CENTRAL COALFIELDS LIMITED
(A Subsidiary of Coal India Limited)
OFFICE OF THE PROJECT OFFICER
VTC BHAVAN, HONHE
AMRAPALI - CHANDRAGUPT AREA

Ref No. GM(AC)/PO(Chandragupt)/23-24/220

Sub: Request for compliance of EDS, raised by MoEF&CC with regard to Forest proposal of the forest Land of 699.38Ha of Chandragupt Project of CCL.

Ref: EDS raised by the MOEF&CC, Dated: 22/09/2023

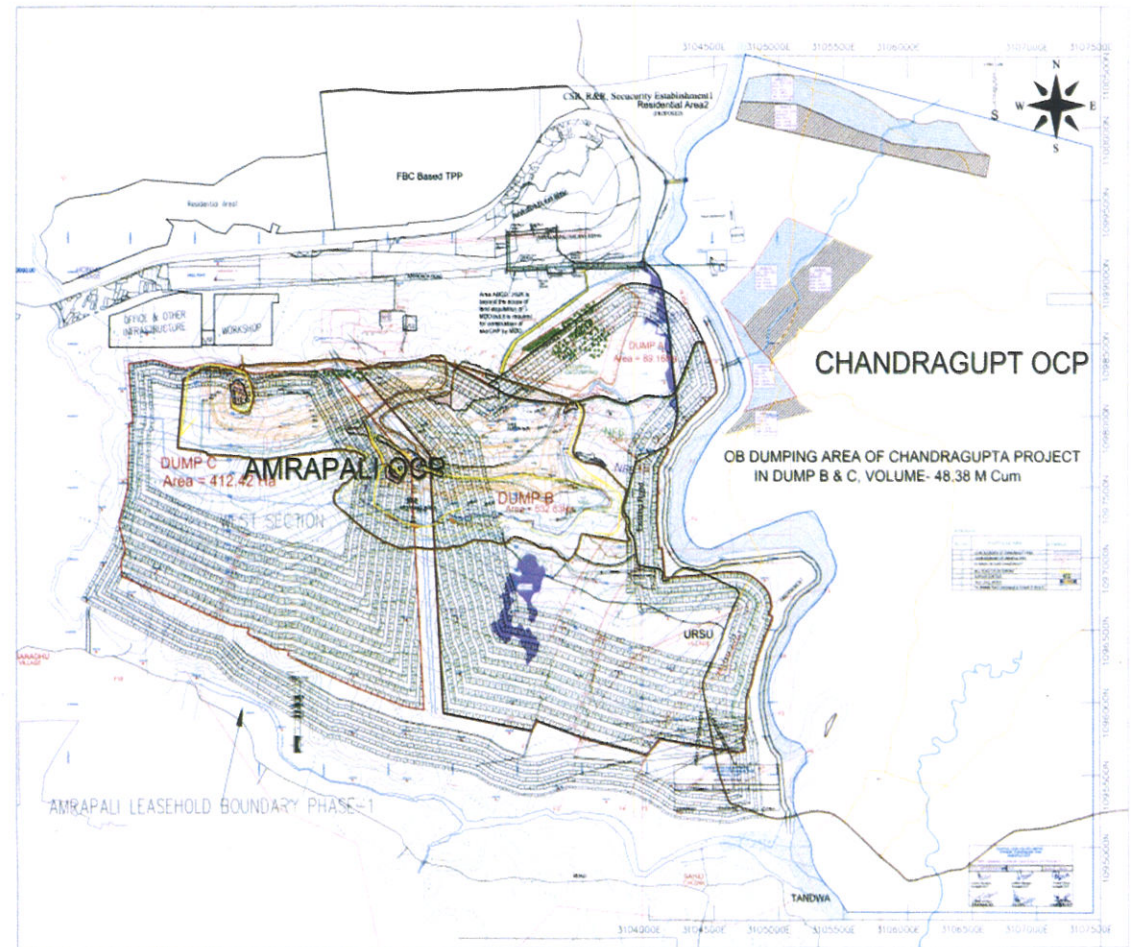
vi)	From the purpose-wise breakup of forest land, the following may be ascertained:

a)	An area of 0.14 ha has been proposed for diversion of Nadi/nalla. The status of feasibility reports for said diversion along with comments of Water Resource Department on the feasibility of said proposed diversion needs to be informed by the State.	<div>1) Chotki stream is a 2nd order and purely a rain-fed stream passing in the north-west of the block from North to south. Diversion of Chotki stream and straightening of the meander notch of Barki River (100 mtrs) are proposed.</div> <div>2) A DPR of Chhotki Stream diversion and straightening of the meander notch of Barki River has been prepared by IIT Roorkee. (The DPR enclosed in the form of CD as Annexure VII). Diversion proposal has been recommended by Chief Engineer (Water Resources Department), Jal Bhawan, Ranchi for issuance of NOC. (The recommendation is enclosed as Annexure VIII).</div>																																																														
b)	An area of 13.94 ha of forest land has been proposed for infrastructure while only 2.3 ha only has been proposed in non-forest land. The State Government may therefore assess the legitimacy of site-specificity of various infrastructural components and possibility to shift non-site-specific components to the non-forest land.	<div>As per the advice of MOEFCC, the land-use proposed in the earlier submitted Form-A has been revised with a view to reduce forest land for infrastructural components. The earlier and proposed land-use is given below:</div>

<table><tr><th colspan="5">Earlier Land-Use for Infrastructure</th><th colspan="3">Revised Land-Use for infrastructure</th><th rowspan="2">% Change in Forest Land</th></tr><tr><th>SN</th><th>Component</th><th>Forest Land</th><th>Non-Forest Land</th><th>Total Area (in Ha)</th><th>Forest Land</th><th>Non-Forest Land</th><th>Total Area (in Ha)</th></tr><tr><td>1</td><td>2</td><td>3</td><td>4</td><td>5</td><td>6</td><td>7</td><td>8</td><td>(3-6)/3</td></tr><tr><td>1</td><td>CHP</td><td>9.30</td><td>5.52</td><td>14.82</td><td>4.45</td><td>3.41</td><td>7.86</td><td>- 52 %</td></tr><tr><td>2</td><td>Infrastructure (Field Workshop, Substation etc)</td><td>13.94</td><td>2.30</td><td>16.24</td><td>0.00</td><td>11.56</td><td>11.56</td><td>- 100 %</td></tr><tr><td>3</td><td>Road, bridge, culvert</td><td>4.38</td><td>14.20</td><td>18.58</td><td>4.38</td><td>14.20</td><td>18.58</td><td>0</td></tr><tr><td></td><td>Total</td><td>27.62</td><td>22.02</td><td>49.64</td><td>8.83</td><td>29.17</td><td>38.00</td><td>-68 %</td></tr></table>

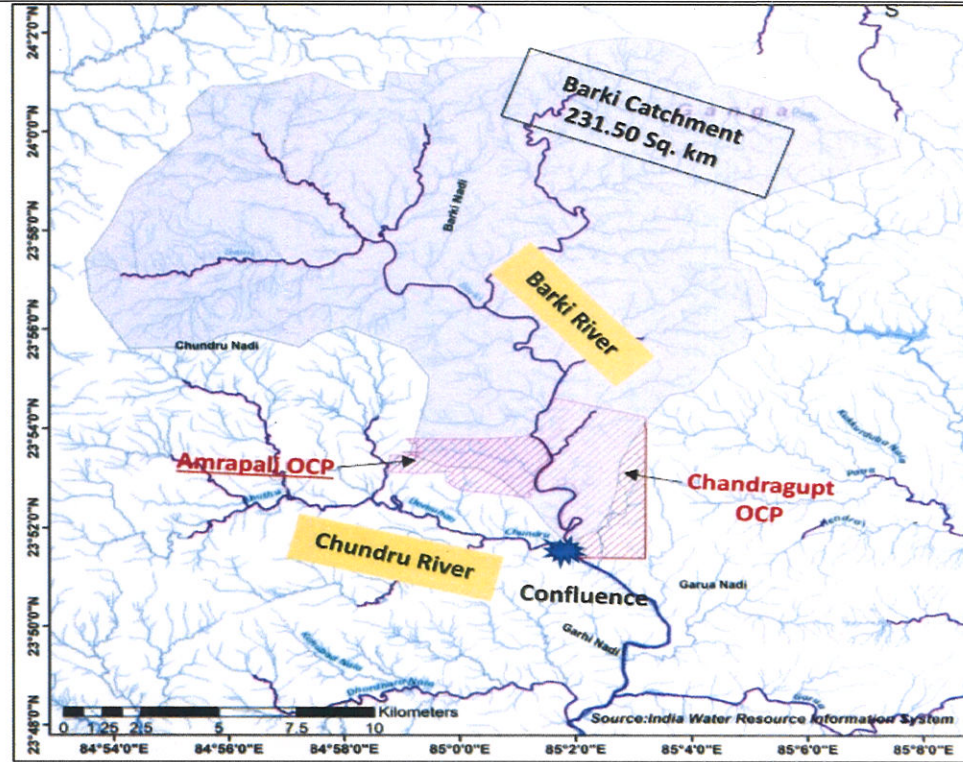
vii Analysis of the area proposed for diversion and area proposed for CA area using DSS analysis revealed the following which needs clarification:

a)	Google imagery shows the presence of Settlements, Roads and Agriculture land etc. within the proposed forest land for diversion	<p>The roads passing through the Forest area within the coal block will be diverted from outside the Coal block boundary along with shifting of village habitat and encroachers at the time of commencement of mining operations. In this regard a request to Road Construction Department (RCD), Govt of Jharkhand was submitted on 15.12.2022 for diversion of the existing road within the project boundary. Subsequently, RCD carried out site inspection of the said road and Executive Engineer RCD requested Chief Engineer RCD for the preparation of DPR for diversion. (Correspondence letters enclosed as Annexure XII).</p> <p>At the time of handing over of forest land for mining activities necessary support will be extended to forest department to make forest area encumbrance free land within coal block.</p>

b)	As per Google imagery, Tandwa Barrage has been constructed after the year 2016 over the Garhi Nadi (River) and part of barrage project is falling in the forest patch which has been proposed for diversion.	<p>On physical verification it was found that barrage is not falling in the forest patch proposed for diversion. The barrage structure is approximately 140 mtrs away from the project boundary. However, a small part of stone pitched embankment is touching the South-Western boundary of the project at an approximate distance of 20 mtrs only.</p> <p>However, it is to mention that in the PR of Chandragupt OCP, a barrier of 100 mtr to be left against the embankment has already been provisioned.</p> <p>Further, as per the approved Project Report of Chandragupt OCP: "The Southern Boundary has been fixed leaving a barrier of 100 mtr from the southern geological block boundary of Pachra South block."</p> <p>As such, the quarry edge will be 100 mtrs away from the embankment. (Barrage Location Plan is enclosed in the form of CD & Hard copy as Annexure XIII)</p>

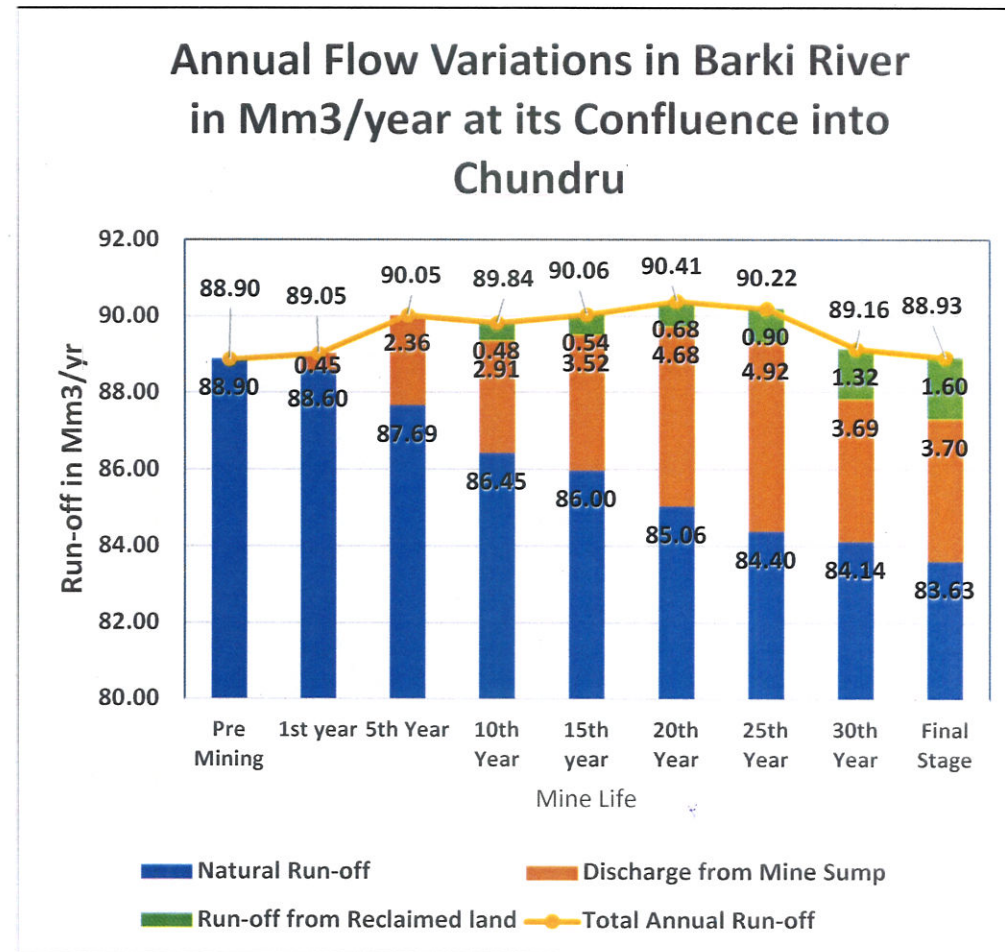
x)	In case Amrapali OCP is not of the UA then an NOC from the UA of Amrapali OCP shall be submitted.	Both Amrapali OCP and Chandragupta OCP are the projects of Central Coalfields Limited under the administrative control of 'Amrapali & Chandragupt Area'. As such, no NOC is required for Chandragupta OCP from Amrapali OCP.
xi)	Amrapali OCP boundary is in the west side of the Barki river, the impact of having mining on both the sides of river will require deep understanding of the impact of hydrology of the river, so comments of the State shall be submitted in this regard.	CMPDIL, Ranchi has prepared a Report on the anticipated impacts of proposed mining on either side of Barki River and its management plan. (Report of CMPDIL is attached as Annexure-XVIII). Following are the key findings of the report: 1) There shall not be any obstruction to the flow of Barki River. Mining is proposed by leaving approx. 100 m on Amrapali side and 60 m on Chandragupt side from the HFL of the River. 2) This safety zone will act as a buffer between the natural stream and active mining area, thereby safeguarding the banks of Barki River from erosion, keeping the catchment area for stream assisted by natural channel slope, sustaining the stream flow, and preserving the riverine eco-system. 3) During heavy rainfall conditions, the active mine sumps will act as surge ponds and effectively reduce the peak flow rates in Barki River. Thus, Barki River will not experience any flooding-related problems during heavy rainfall. Additionally, as part of the study on diversion of Chutki nalla, IIT Roorkee has conducted a study on Barki river also. The study states that Barki has a catchment of 231.50 sqkm.

The Barki watershed and the corresponding locations of the Amrapali and Chandragupt mines are depicted in the above figure. It can be observed that both Amrapali and Chandragupt mines are located in the southernmost portion of the Barki watershed, at its confluence with Chundru stream.

Of the entire Barki catchment area of 231.50 sq. km, only 6.40% (=14.94 sq. km) is designated for mining under both Amrapali and Chandragupt. It is to note that annual run-off from Barki River catchment is 88.90 Mm³, majority of which is contributed by belly portion falling in North and North-East part which remains unaltered by mining.

In the IIT-Roorkee study, peak flow of Barki River near the proposed mining area was modelled for 50-year return period using HEC-RAS software. Key aspects are as under:

- As per the said study, the predicted HFL of peak flow of Barki is found to be lower than the corresponding river banks, suggesting no risk of flooding on the surrounding landscape.
- Whereas, due to proposed mining activities, a slight draw-down in the discharge of Barki is expected during the lean period. However, ample amount of excess mine seepage will be pumped from the mine voids of both Amrapali and Chandragupt to Barki River after proper treatment to maintain the lean flow.
